Sixth HYDROCOIN workshop

Complementary specifications on levels 2 and 3

Re: Level2/Case4 output format change

Addendum to HYDROCOIN Level 3 Case 7

- Figure 20.

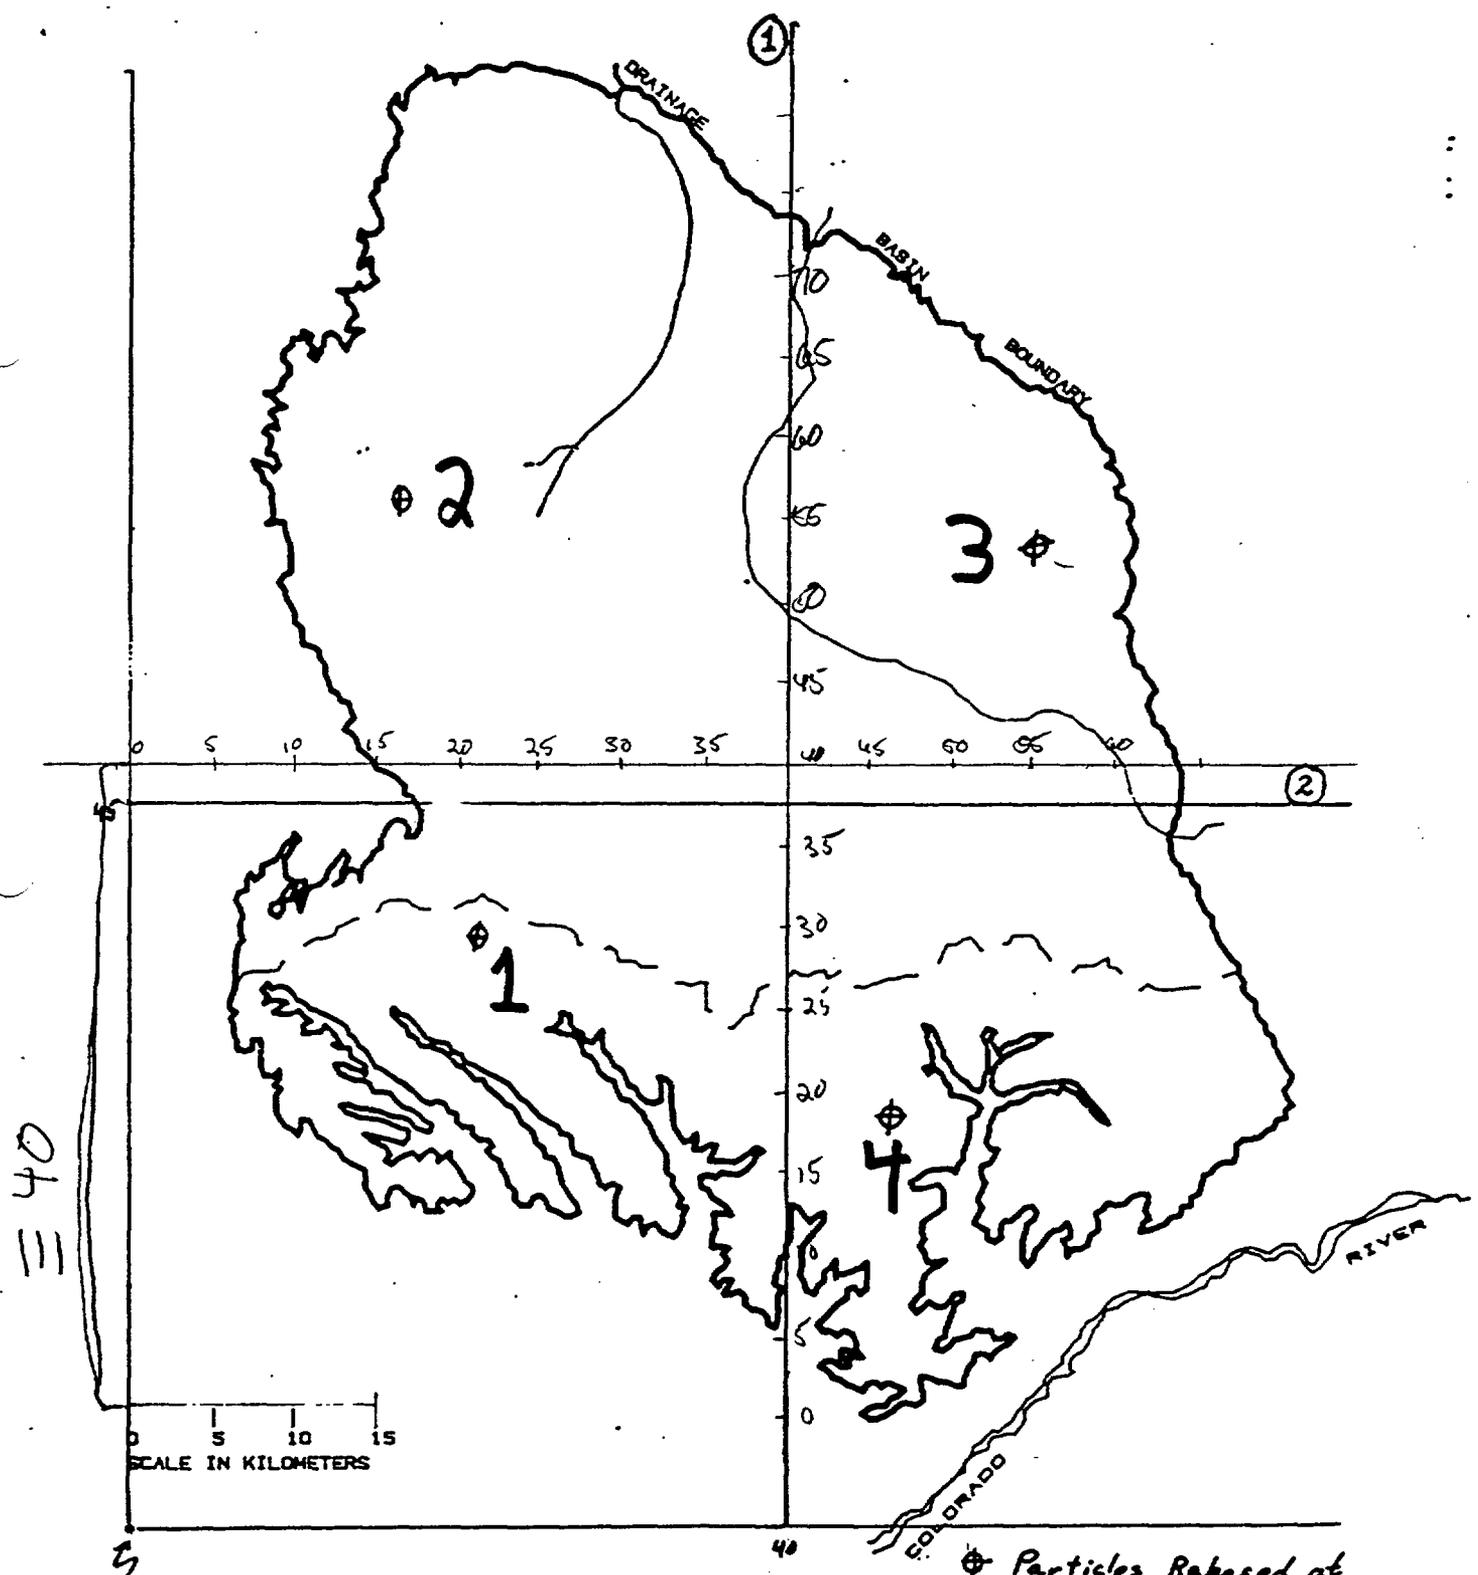
The following output format for model error and particle trajectories supercedes the format given on page 4 of the problem definition:

Line 1: Line number as shown in figure 20, FORMAT(I5)

Line 2-: x or y (meters), error(1),error(2),error(4),error(5)
where 1,2,4,5 refer to the model layer numbers with
layer 1 at the bottom, FORMAT(5(3X,E12.5))

Line 1: Layer number, Trajectory number (see enclosed figure),
Number of points, FORMAT(3I5)

Line 2- x(meters), y(meters), z(meters), accumulated length
(meters), and accumulated time(seconds),
FORMAT(5(3X,E12.5))
